## Discussion of Major Issues Associated With EPA's Compressed Waste Review

### **General Background on AMWTF Compressed Waste**

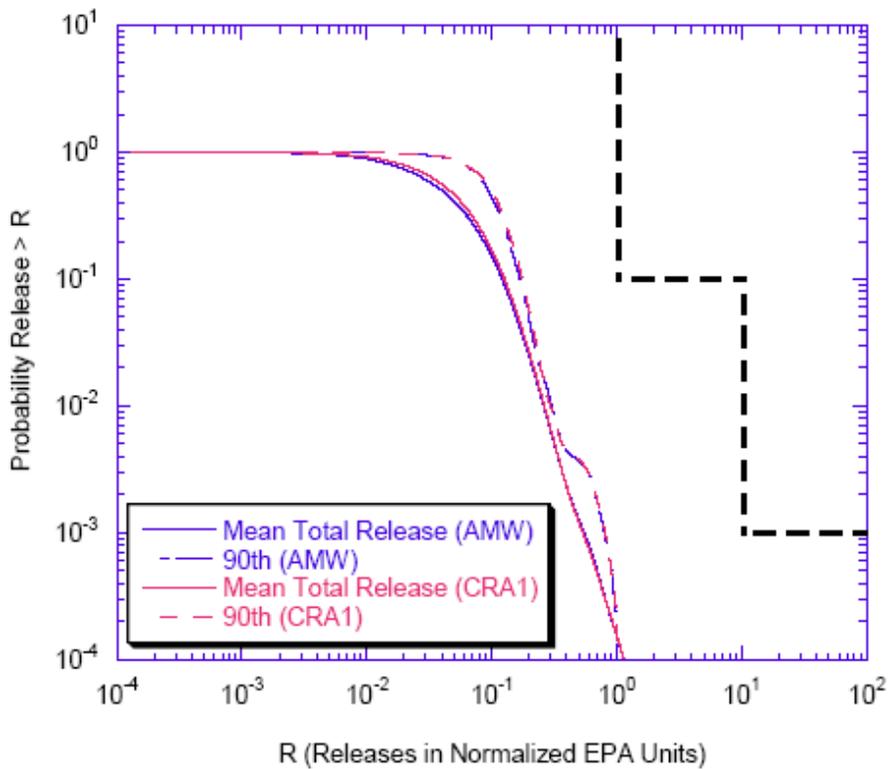
Since the AMW PA inventory and the 2004 CRA use the same inventory, DOE chose to compare the AMW PA with a modified CRA PA<sup>1</sup>. In this comparison, the set of CCDF (cumulative complementary distribution function) curves for total normalized releases are almost indistinguishable. The mean total releases and the 90<sup>th</sup> quantile releases are almost identical. The porosity concerns EPA identified in the review and discussed below should not affect these results because additional analyses showed that important results are not affected by use of constant porosity or porosity surface. EPA's concerns related to the uncertainty are satisfied with a review of the means and 90<sup>th</sup> quantile of total releases presented in Table 1 and Figure 2.

However, the current regulatory baseline for PA is the PAVT conducted as part of the original certification decision process. As presented in Table 1 the AMW PA releases are lower than the PAVT at the 0.1 probability but higher at the 0.001 probability. While different from the PAVT, the higher releases at 0.001 are not due to AMW PA waste. Instead the differences appear to be due to an increase in cuttings and cavings releases. The cuttings and cavings releases appear higher because a few non-AMWTF waste streams with high radioactivity were sampled.
